## FINAL DESIGN REPORT

FOREST HOME DRIVE  
OVER  
FALL CREEK

B.I.N. 3047450

April 2010

**FIGURE 5**

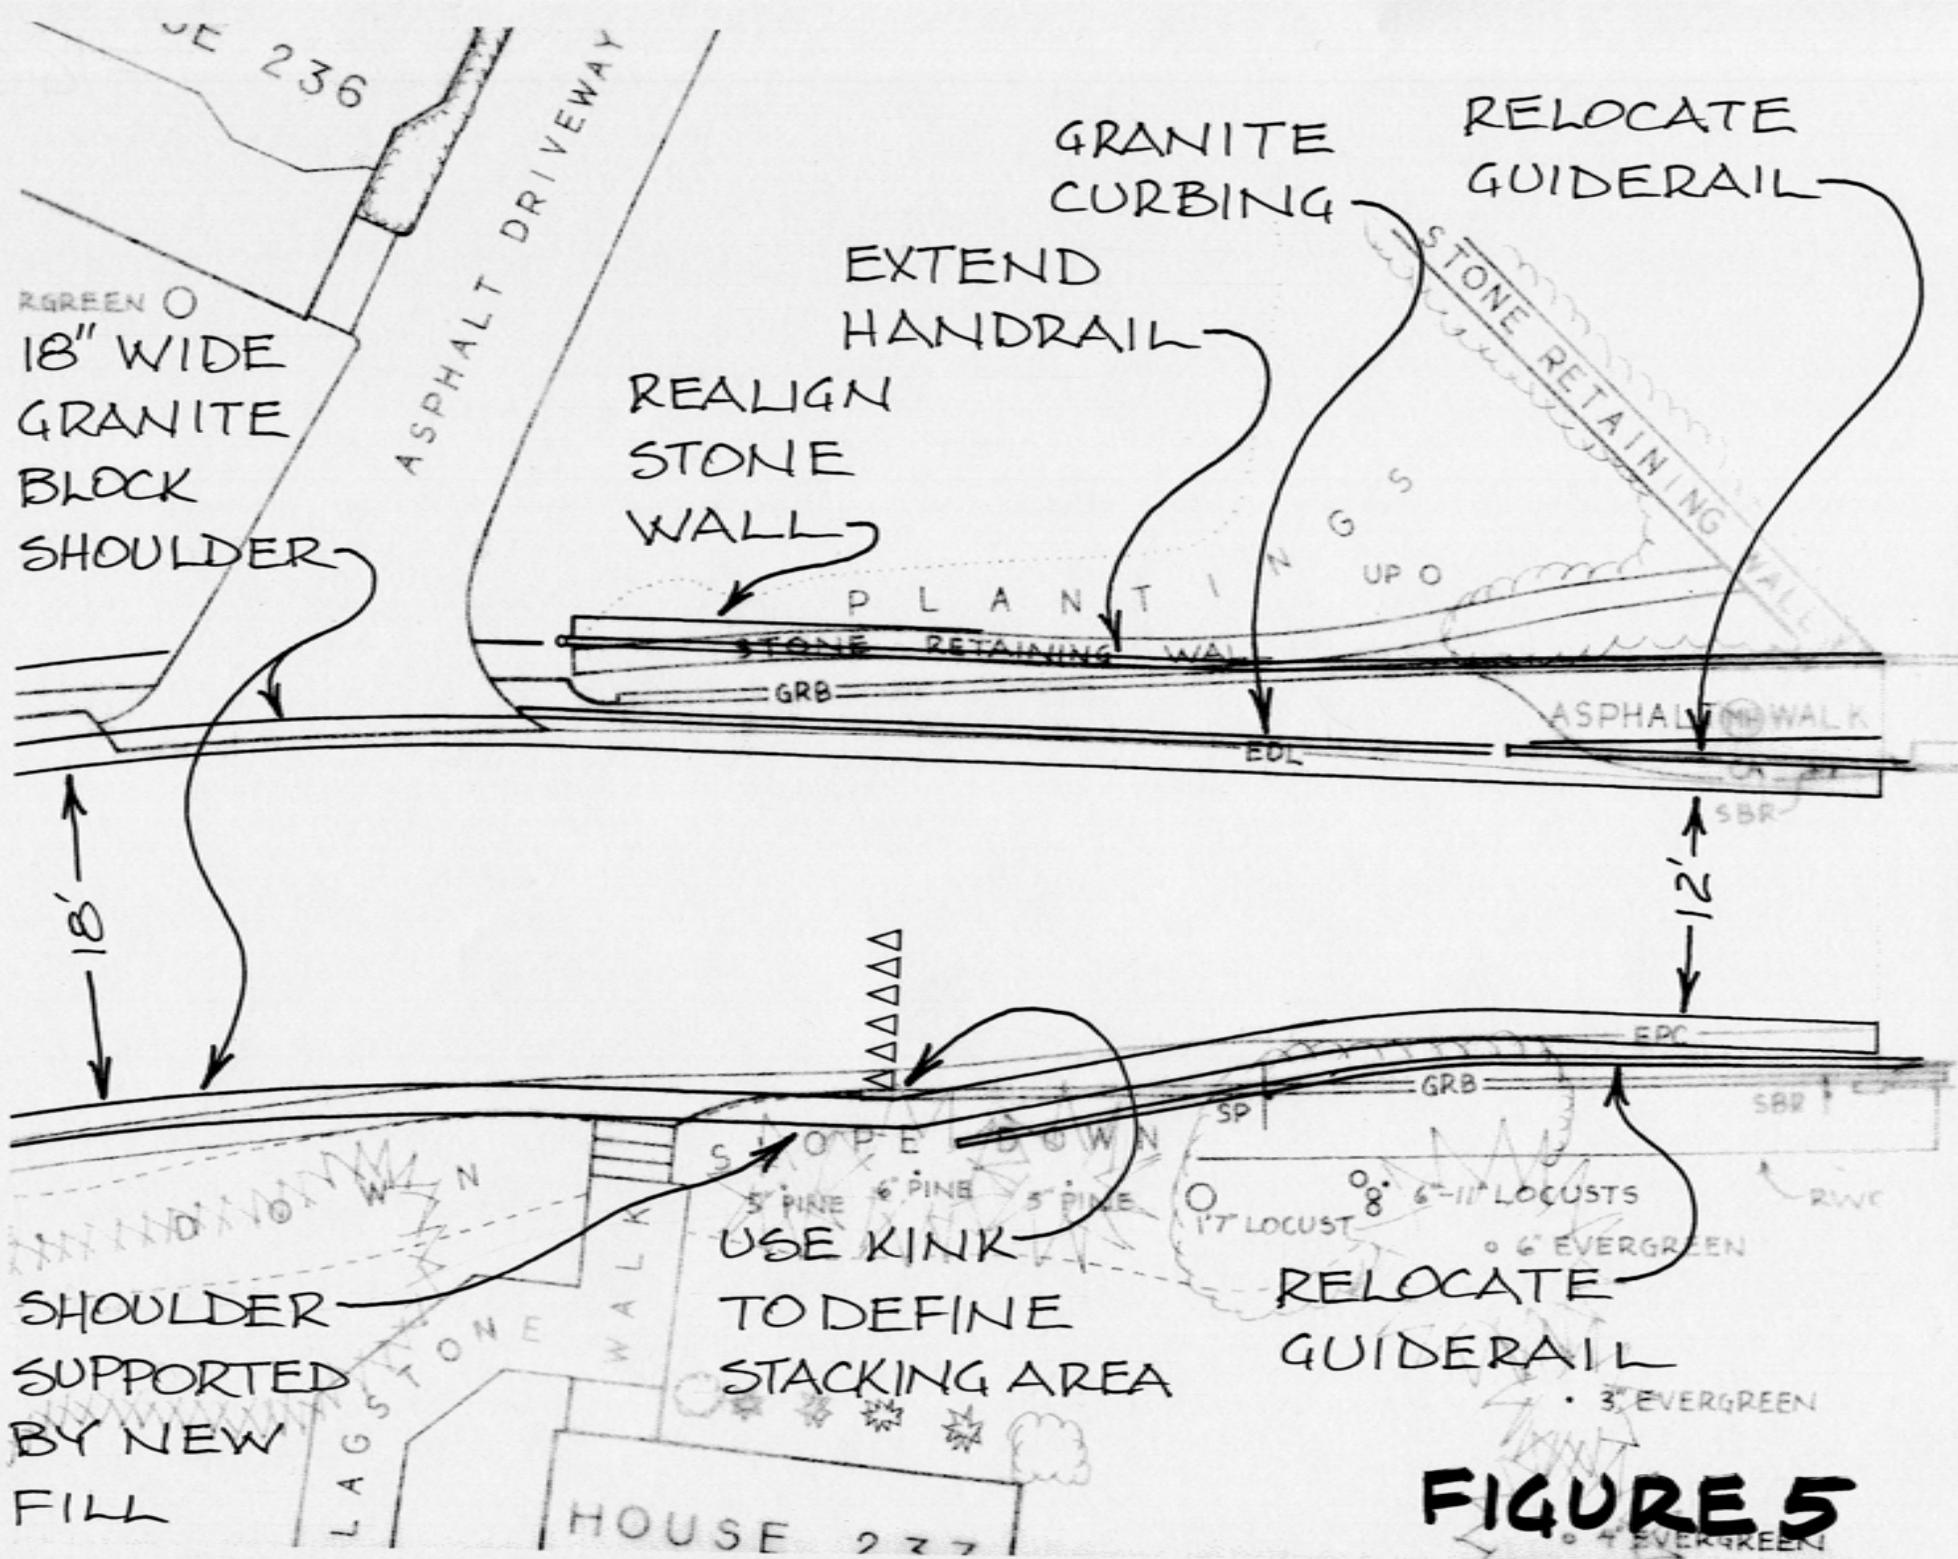
**Figure 5** Minor intrusions on properties to both the north (Shipe, 236) and south (Chambers, 237)

- Granite block shoulder is 18 in wide on both sides of road.
- Kink in shoulder at Yield line (white painted triangles) defines head of stacking area for bridge.

- Shoulder on south side of road extends onto new fill. Modify slope on south side of road (Chambers, 237) with fill or minor retaining wall to support granite block shoulder, which extends 18 in beyond existing asphalt at top of slope.
